RE: Public Notice regarding SPK-2019-00899, Application, Delta Conveyance

Please accept the following comments, submitted on behalf of California Water

Figure 2 Tunnel settlement trough

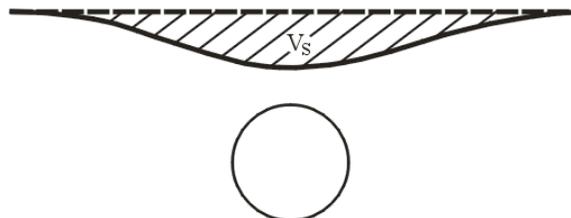
Tunneling boring machines excavate a larger amount of soil than is replaced by the volume of the tunnel lining, which typically causes a wide, shallow settlement trough on the surface. The over-excavation is measured by the volume of ground loss, which is defined as the percent difference between the volume of excavated soil and the volume of the tunnel lining. The volume of the settlement trough on the surface can be as large as the volume of ground loss. If groundwater is drained for tunnel construction, soil layers above the tunnel could settle even further.

Similar calculations of ground loss and settlement should be included in the EIS. Without such analysis, there can be no assessment of needed monitoring and mitigation, and the discussion in the EIS of channel crossings will be incomplete.
